Re: NCIRT Review and USACE Approval of the Catfish Pond Mitigation Plan; SAW-2018-00424;
NCDMS Project # 100039

RE: Response to IRT comments on Draft Final Mitigation Plan Submittal
Catfish Pond Mitigation Site, Durham County, NC
Neuse River Basin - 03020201
DMS Project ID No. 100039 / DEQ Contract #007424

Catfish Pond Mitigation Plan Comments

RE: Response to DWR comments on Draft Final Buffer Mitigation Plan Submittal
Catfish Pond Mitigation Site, Durham County, NC
Neuse River Basin - 03020201
DMS Project ID No. 100039 / DEQ Contract # 007424

Catfish Pond Mitigation Site
 Durham County, North Carolina
 UTI Wetlands
 Stand-Alone Sheet

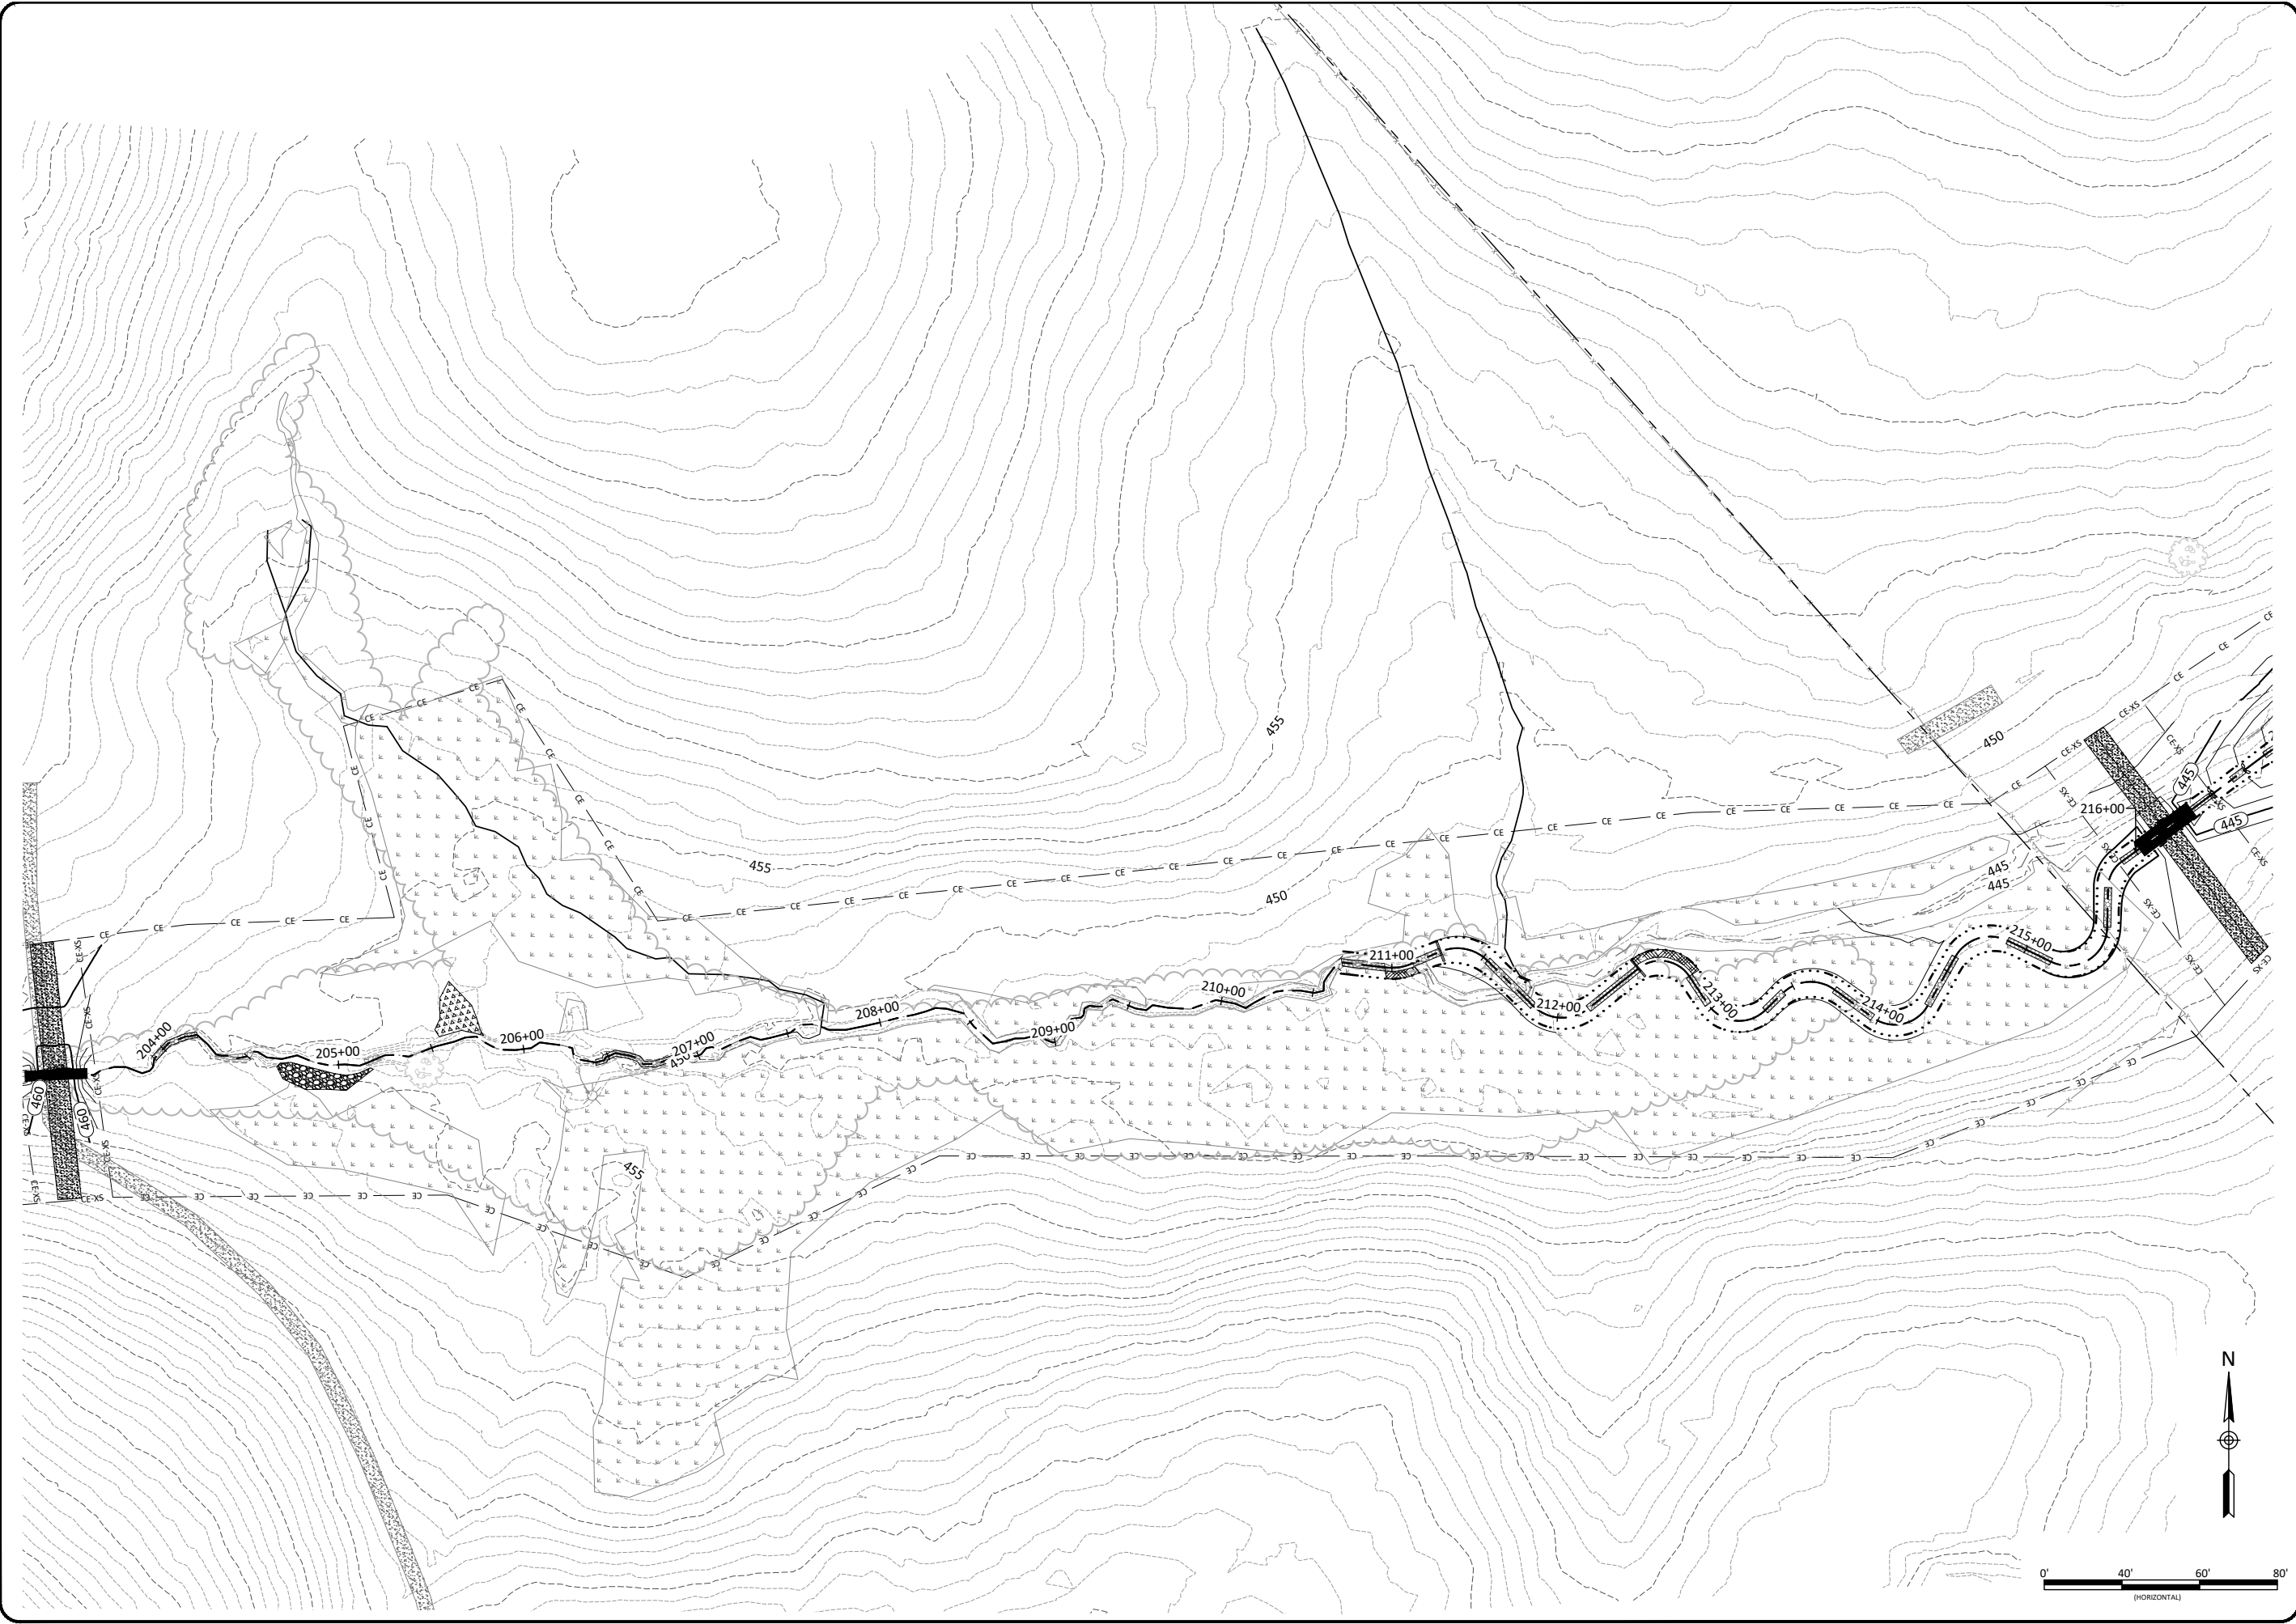
7. *Design Sheet 2.10 – DWR would like to see a design sheet that shows all the newly capture wetland area adjacent to UT1.*

A PDF of the requested area is included at the end of this comment-response letter.

Figure 8 Concept Design Map
 Catfish Pond Mitigation Site
 Neuse River Basin 03020201

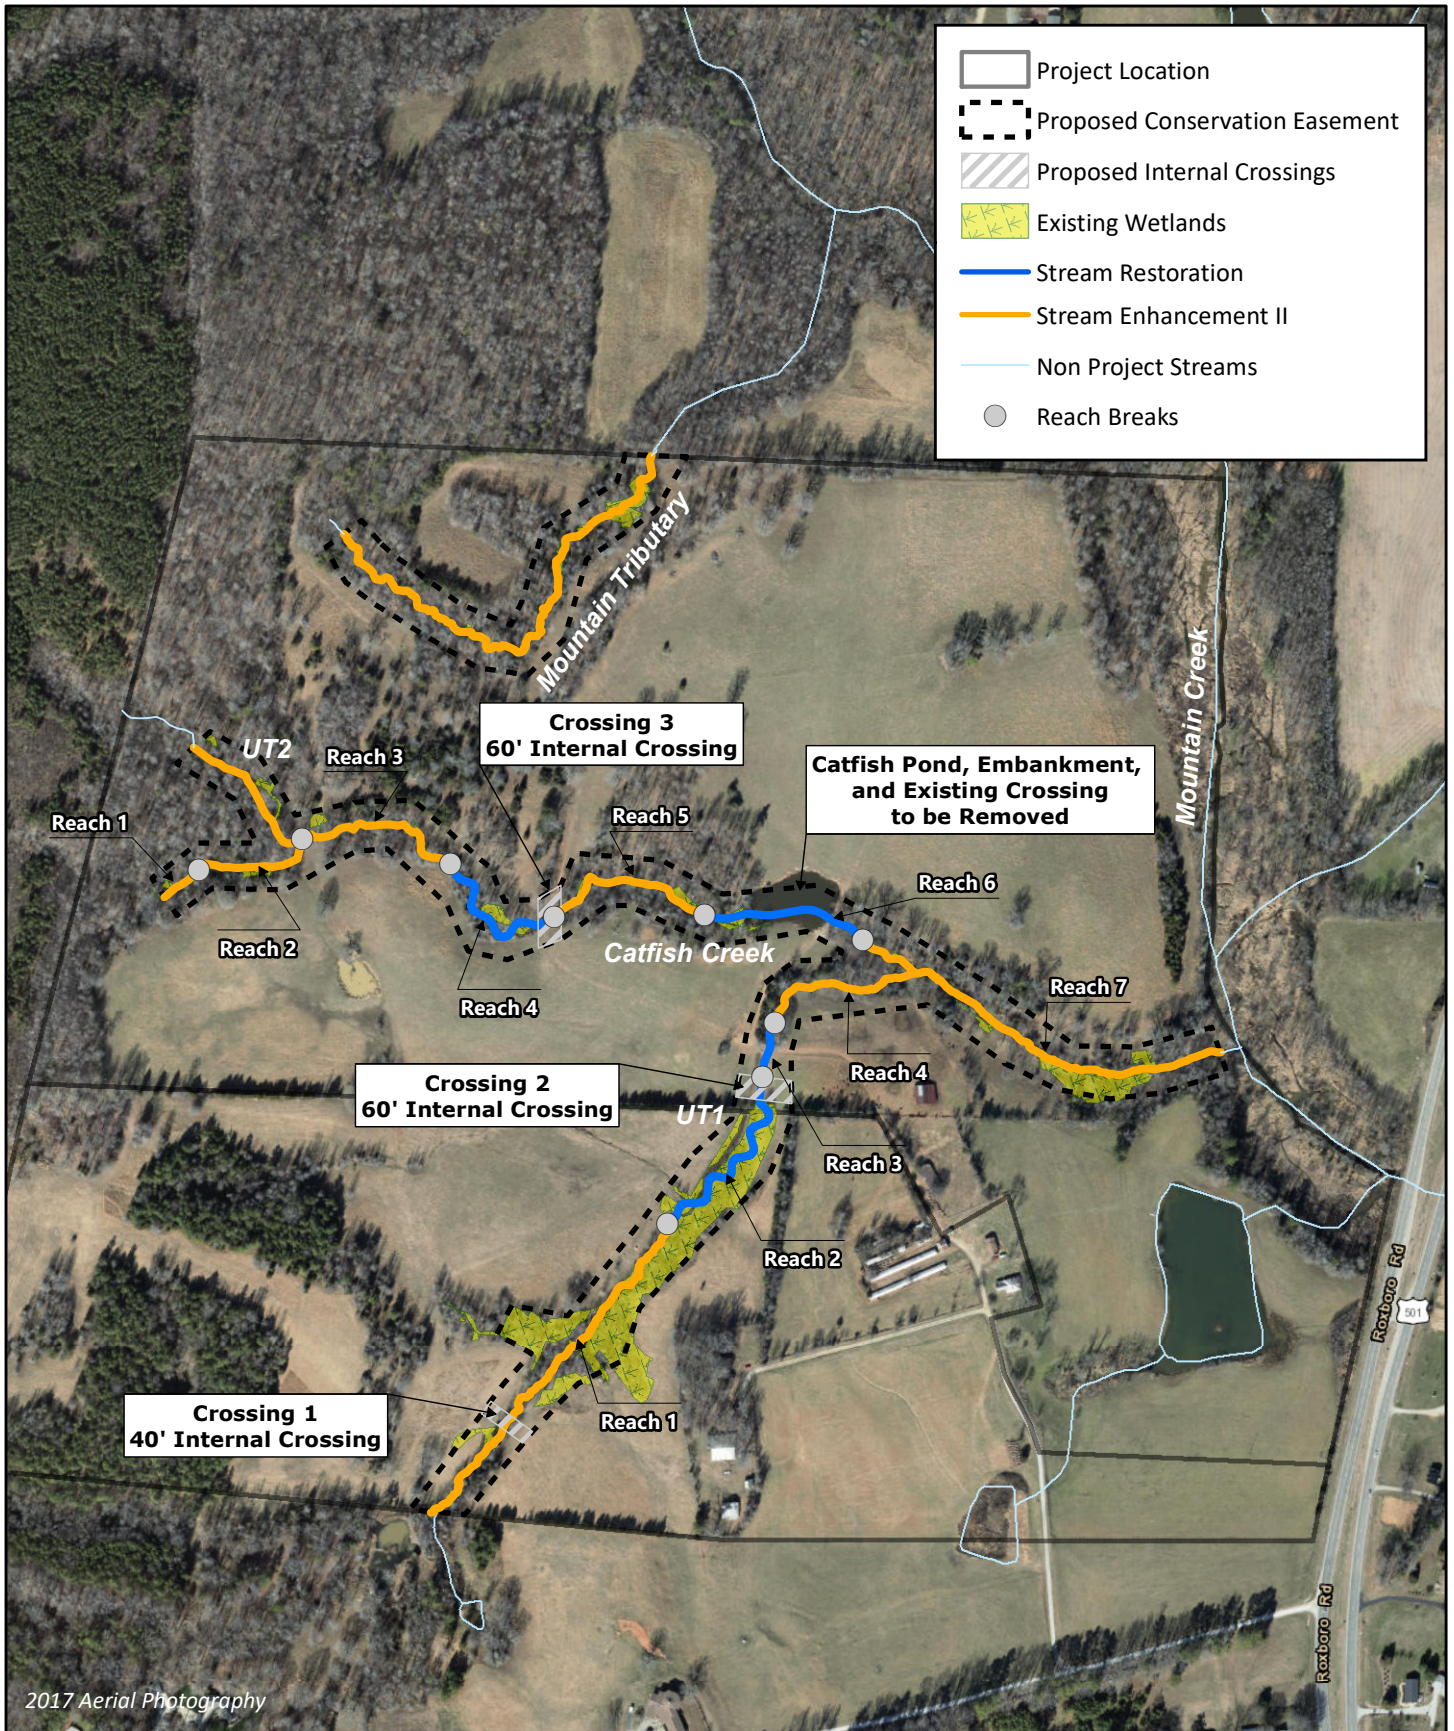
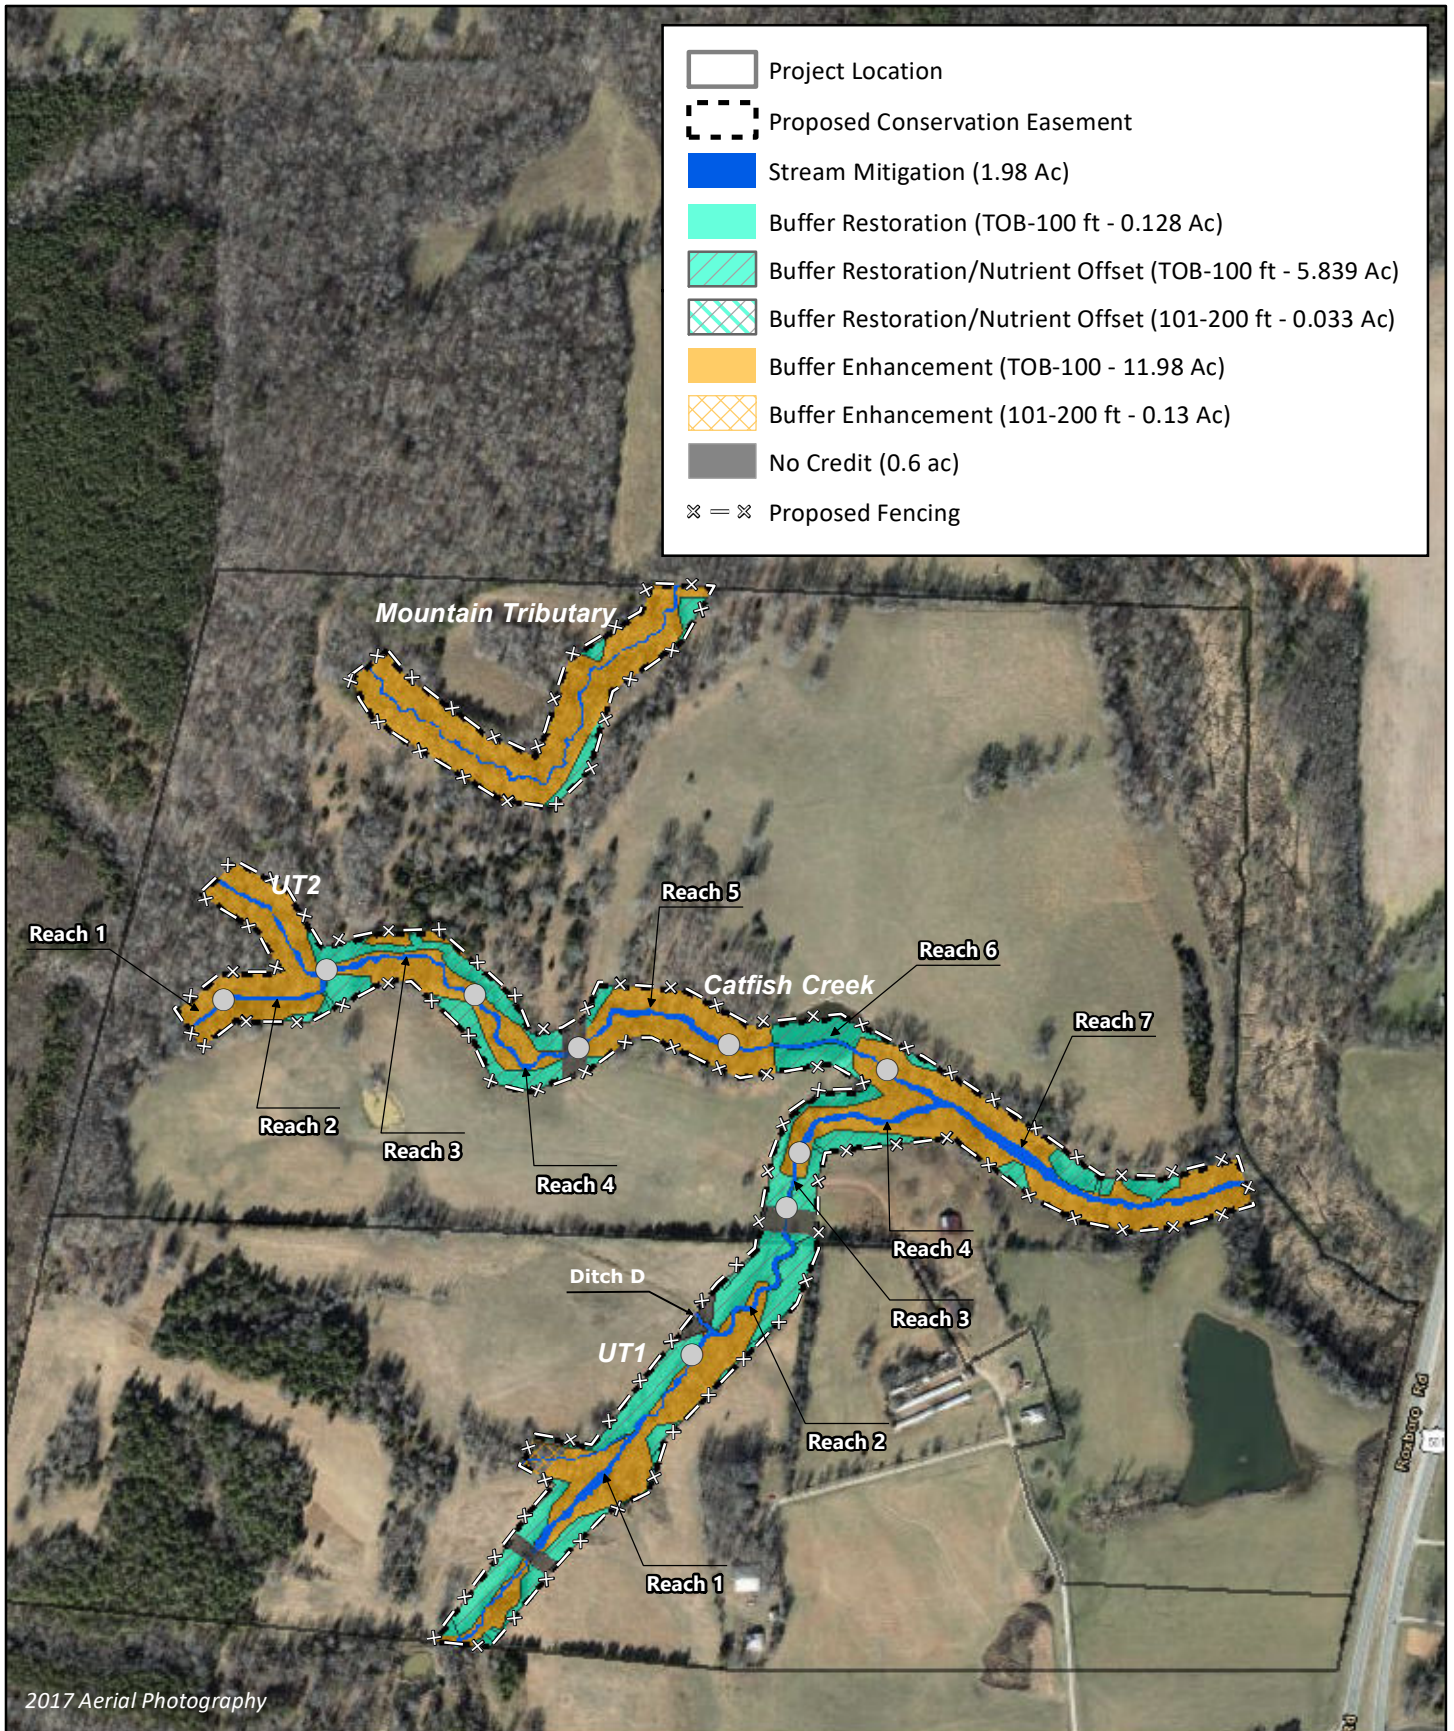
1. *A concept plan is provided on Figure 8. Please revise this plan to show where buffer mitigation and/or nutrient offset are also being generated.*

Wildlands has added Figure 8a to show the overlap of all the mitigation types on the project.

Catfish Pond Mitigation Site
Durham County, North Carolina
Plan and Profile
UT1

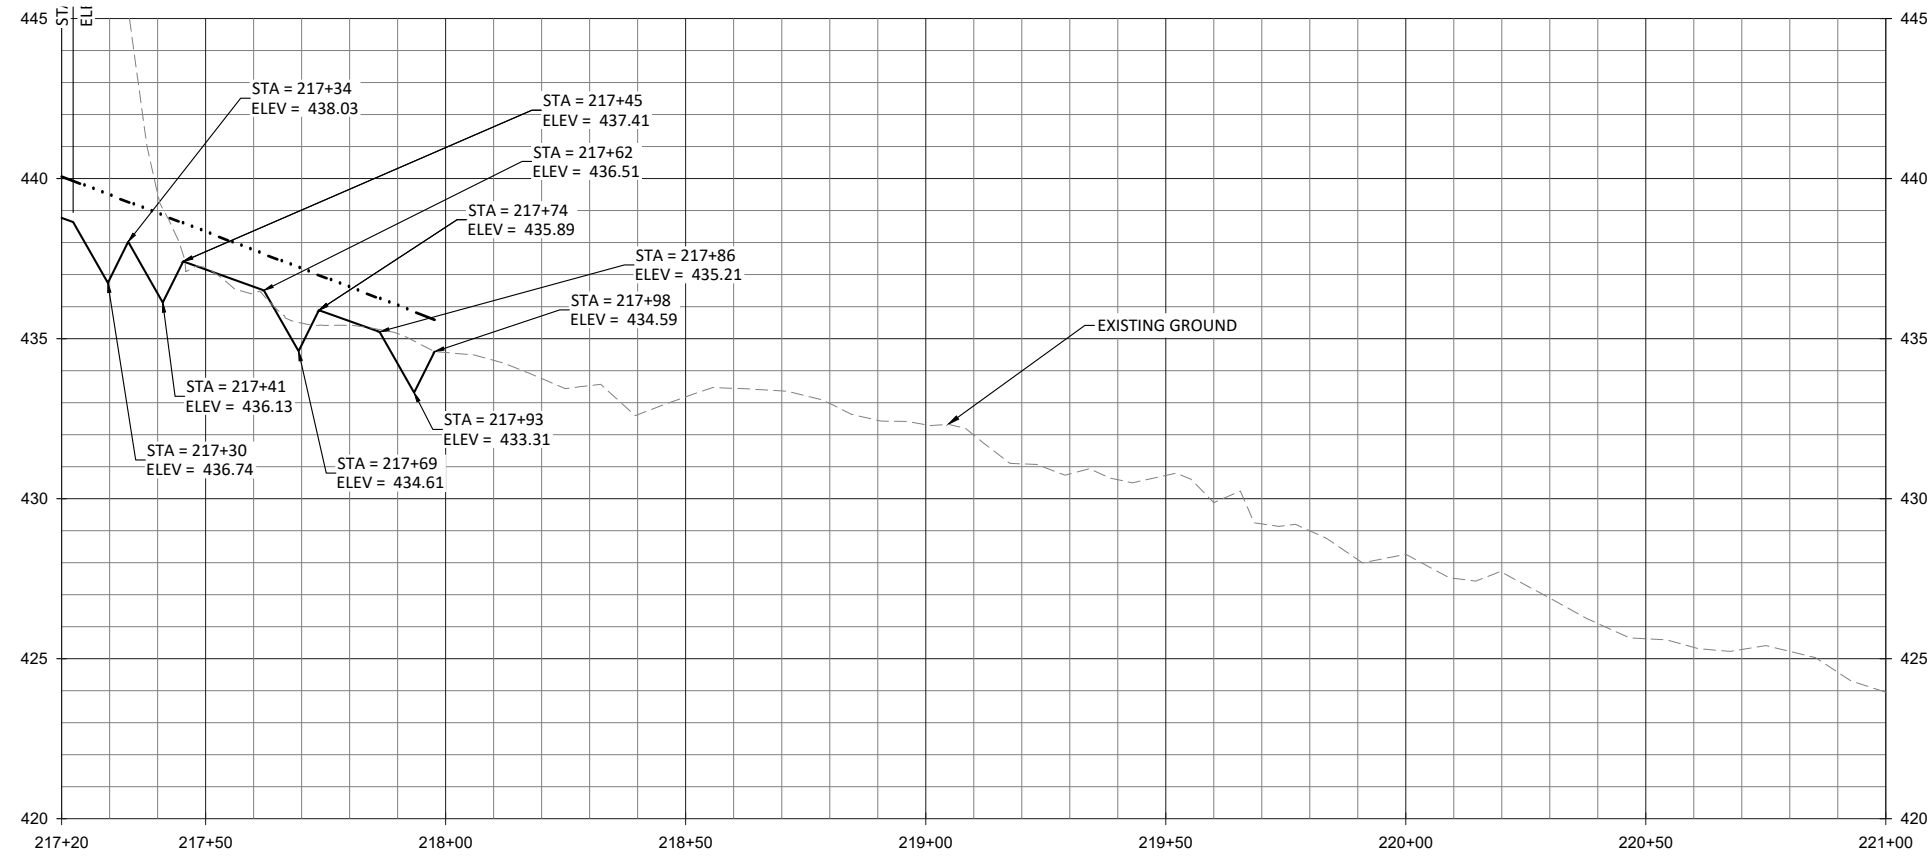
1. Plan Sheet 2.12: Is inserted upside down, and it states that the reach-wide treatments include fencing, treating invasives, supplemental buffer planting, and spot repair on eroded banks, but it appears that P1 restoration is planned on this reach (UT1 Reaches 2 and 3). Please justify why this is restoration at 1:1 if restoration is not actually planned, or correct the treatments statement.

This section is restoration. The note on this sheet has been revised.
